Response to Submissions

State Significant Development Application (SSD 9691)

Warehouse and Distribution Facility

28 McPherson Street, Banksmeadow

Figure 2: Registered Plan of Subdivision Lot 9 DP 1205673

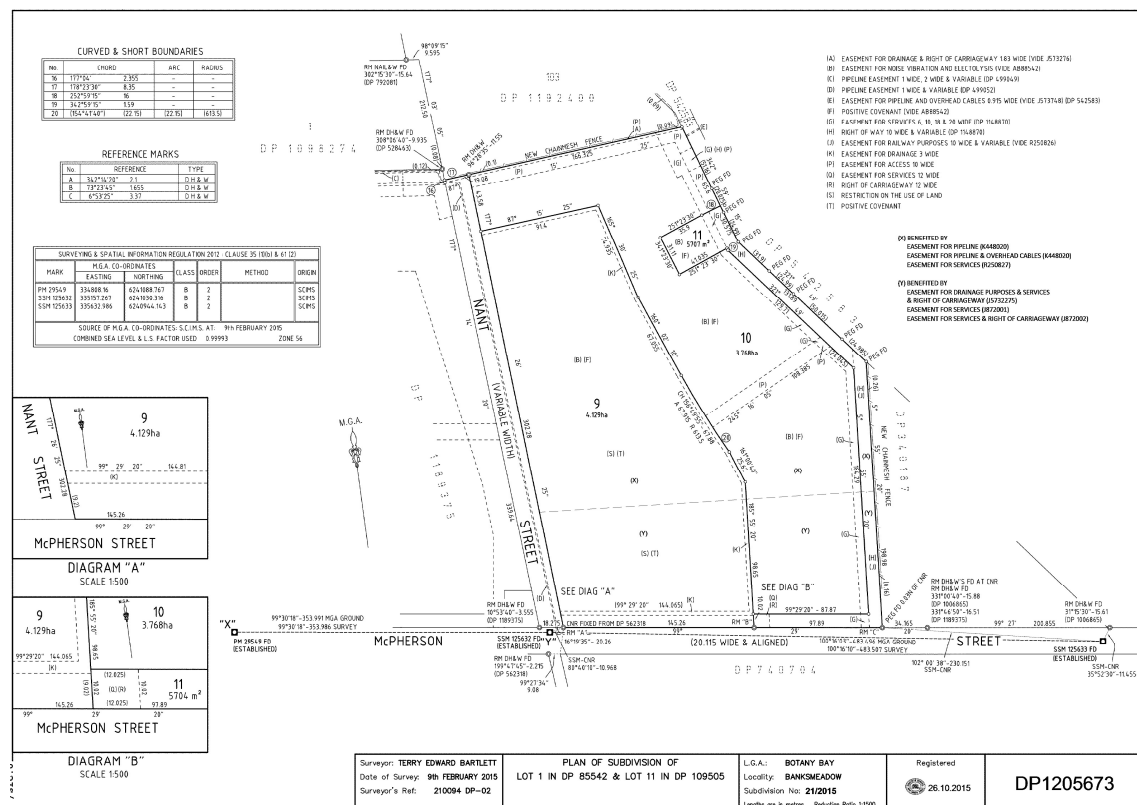
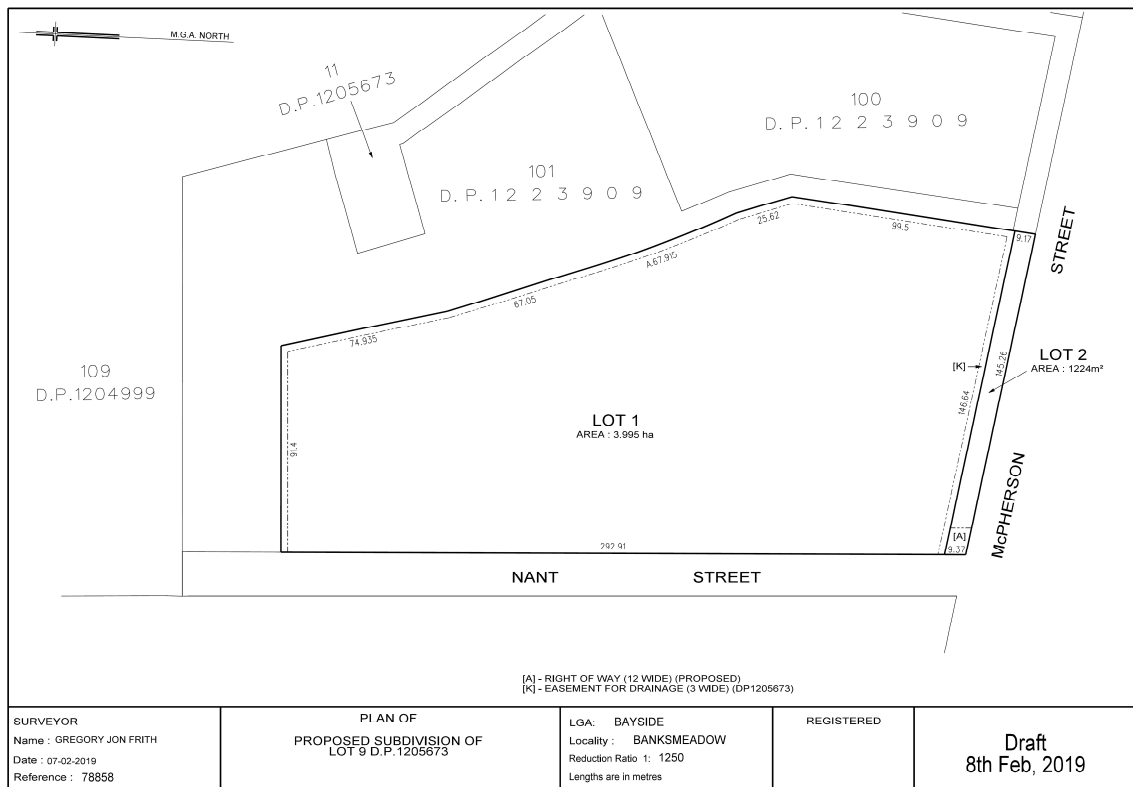
The proposed amendment involves the subdivision of existing Lot 9 DP 1205673 into two lots, with Lot 1 (approximately 0.1224 ha) being an approximate 10 m wide strip of land fronting McPherson Street and the remainder of the parent Lot becoming Lot 2 (approximately 3.995 Ha). The current plan of subdivision of Lot 9 is provided in Figure 2, with the proposed plan of subdivision shown in Figure 3 and Appendix A.

Figure 4: Revised layout plan (Source: Axis Architectural)

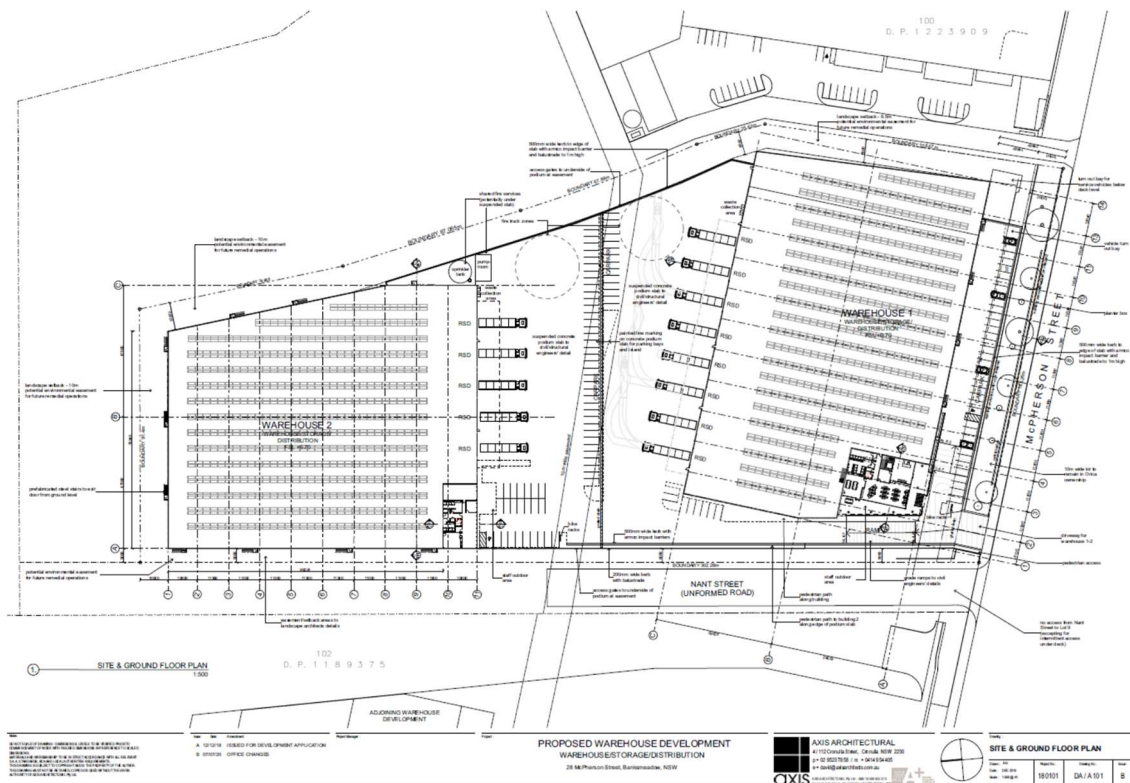
The proposed development layout is amended to consolidate the majority of office space servicing the site to Warehouse 1 with a smaller office space for managing docking operations at Warehouse 2 (Figure 4).

Layout changes include the removal of the mezzanine office floor level in Warehouse 2 and associated changes to the car parking configuration, with no change to the number of parking spaces servicing Warehouse 2.
